**NSLPP MEETING HELD ON 04/09/2024****Attachments:**

**ADDRESS:** 47 Kareela Road, Cremorne Point**APPLICATION NO:** DA 81/22**PROPOSAL:** Alterations and additions to an existing detached dwelling including a two storey rear addition and a new garage structure at the rear with a driveway bridge to Kareela Road**PLANS REF:**

**OWNER:** Richard and Ione Churcher**APPLICANT:** Ione Churcher**AUTHOR:** Report of Robin Tse, Senior Assessment Officer**DATE OF REPORT:** 27 August 2024**DATE LODGED:** 20 March 2022 (and 03 July 2024 [per 38 EP&A Regs 2021])**DATE AMENDED:** 13 June 2024**RECOMMENDATION:** Refusal

**Figure 16: Maximum building height**

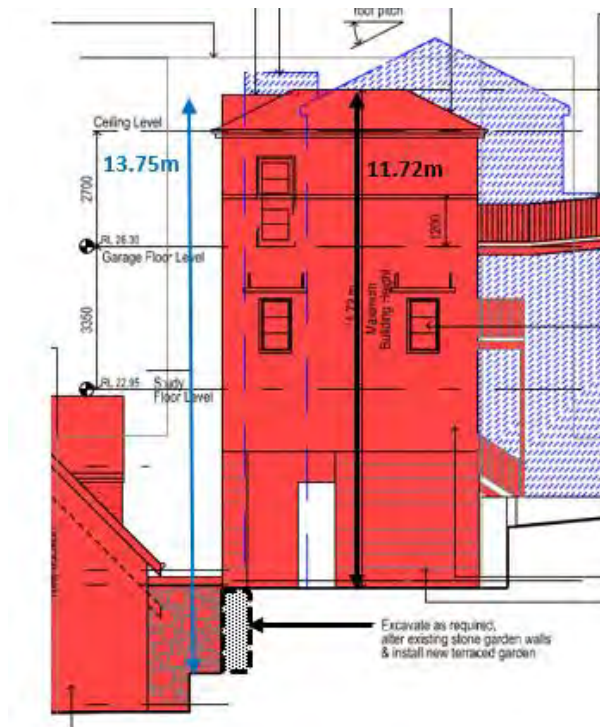
A review of the survey plan submitted with the DA and the submitted architectural drawings has revealed that the construction of the proposed garage structure would require modifications to the existing stepped garden terrace to the rear of the main dwelling and the construction of new retaining walls on the garden terrace to provide the base for the eastern side of the garage structure. Therefore, it is considered that the height of the new retaining wall on the stepped garden terrace should be included as part of the building height calculation. The maximum building height using a digital measurement software (Objective Trapeze) would be 13.75m as show on **Figure 16** below.

In addition, the submitted survey plan indicates that the level of the garden bed at the base of the eastern building line of the garage structure at RL 16.94. The building height as measured from RL16.94 to the top of the proposed lift shaft (that is approximately 230mm lower than the ridge height of the garage structure at RL29.82) would be 12.88m.

**Figure 28: Mid-winter shadow diagrams (45 Kareela Road – Northern elevation)**

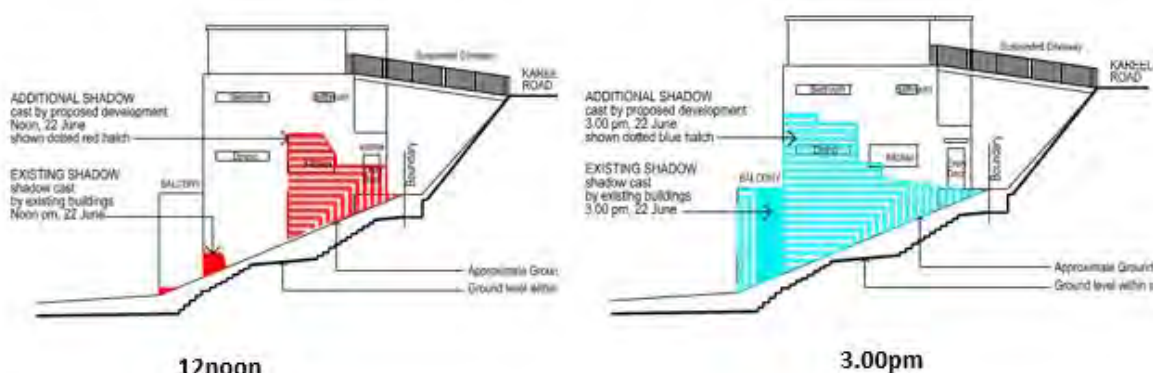
The shadow diagrams submitted by the applicant has indicated that the non-complying building elements would cause shadowing of the kitchen window before 12noon until 3pm during mid-winter. Therefore, the kitchen window is likely to received less than 3 hours of sunlight between 9am and 3pm on 21 June.

This would be contrary to the DCP solar access requirement for a minimum of 3 hours of solar access to windows of main living areas of adjoining residential properties during mid winter.

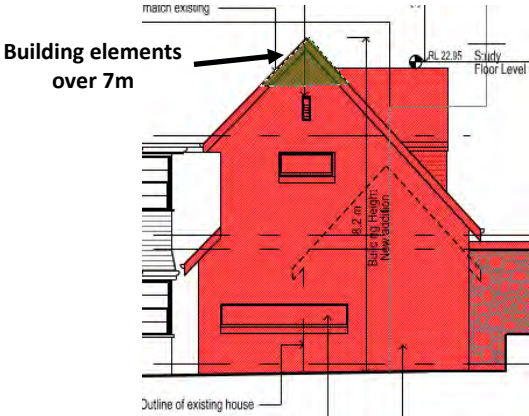
It is noted that the amended proposal involves the lift structure be moved towards the northern property boundary by approximately 2m. Whilst the submission of a further geotechnical report for the amended proposal may address the relevant provisions of Clause 6.10 of the LEP, the absence of such report does not provide the necessary information/evidence to demonstrate that the proposal is satisfactory in this regard.
